Re: **PETITION NO. 1348** – Safari Energy, LLC, as agent for West Farms Mall, LLC, petition for a declaratory ruling, pursuant to Connecticut General Statutes §4-176 and §16-50k, for the proposed construction, maintenance and operation of a 2.019-megawatt AC solar photovoltaic electric generating facility located at West Farms Mall, 1500 New Britain Avenue, West Hartford and 500 South Road, Farmington, Connecticut.

Petition No. 1348
West Farms Mall, LLC /Safari Energy, LLC
Interrogatories
Set One

EXHIBIT A
ArcGIS Farmland Map

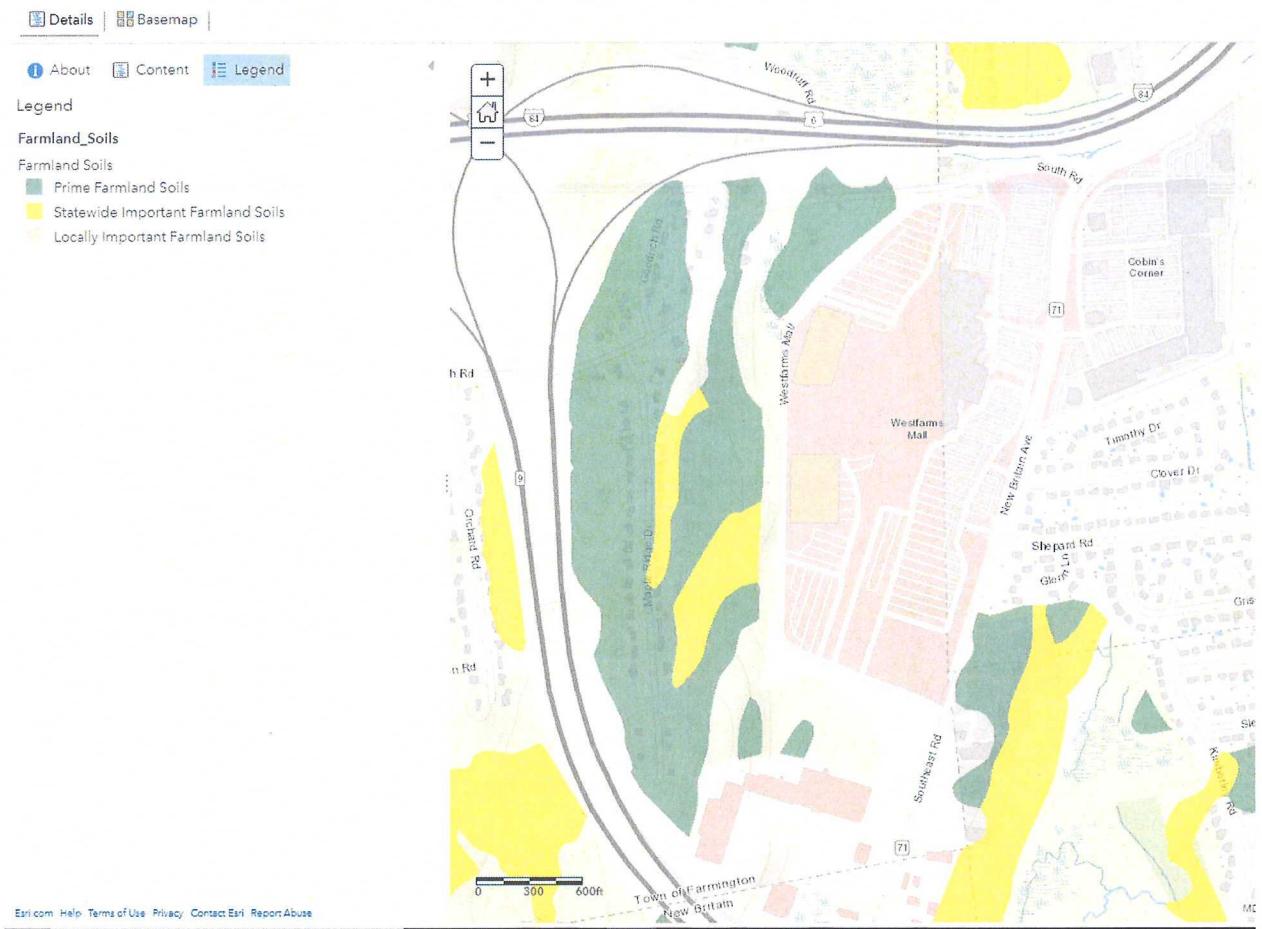
1. Pursuant to Connecticut General Statutes §16-50k(a), has Safari Energy, LLC (Petitioner) obtained a letter from the Connecticut Department of Energy and Environmental Protection (DEEP) that the proposed facility will not materially affect the status of core forest or a letter from the Connecticut Department of Agriculture (DOAg) that the proposed facility will not materially affect the status of prime farmland? Please submit any correspondence submitted to and/or received from DEEP and/or DOAg relative to the proposed facility.

- The facility is proposed to be constructed on an existing, paved parking area serving a commercial shopping mall. There is no core forest nor is there prime farmland located in the proposed location of the facility and therefore no letter from the DEEP or DOAg is required. Attached are screenshots from the ArcGIS online maps showing farmland classifications (Exhibit A) and forestland habitat impacts (Exhibit B), and demonstrating that the proposed location does not include any such forest or farmland.

EXHIBIT C

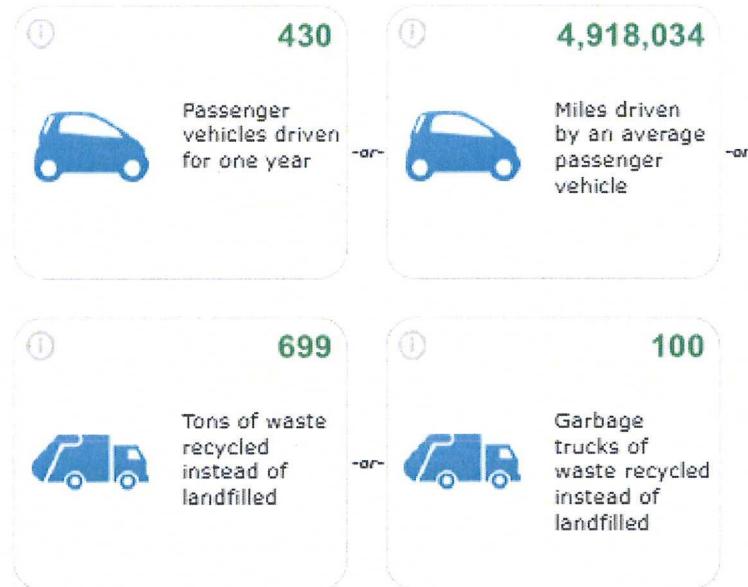
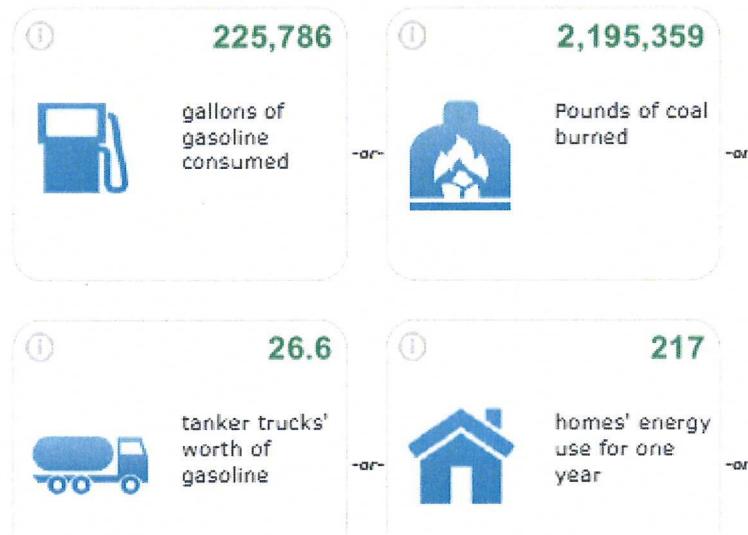
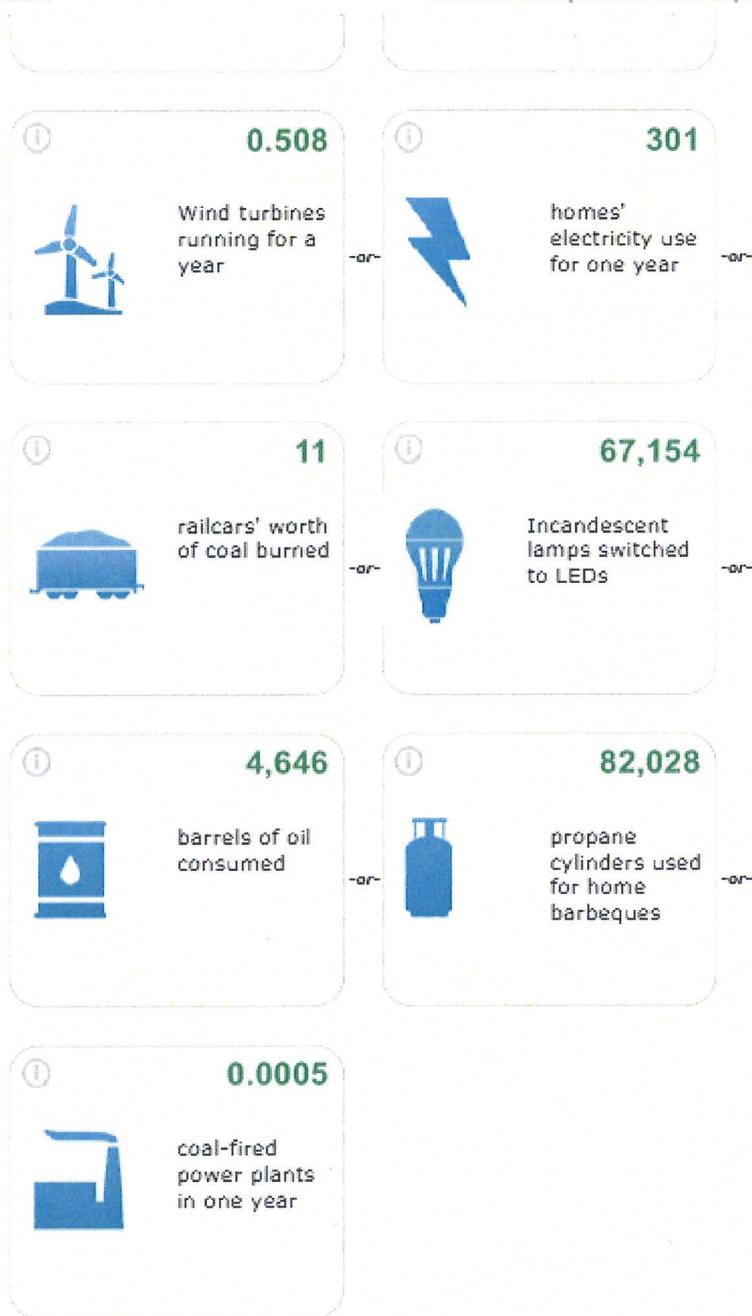
26. For the purpose of demonstrating greenhouse gas emissions reductions for the proposed project (and as a supplement to page 8 of the Petition), please utilize the EPA Greenhouse Gas Equivalencies Calculator at <https://www.epa.gov/energy/greenhouse-gas-equivalencies-calculator> and submit the full results.

- Please see attached Exhibit C
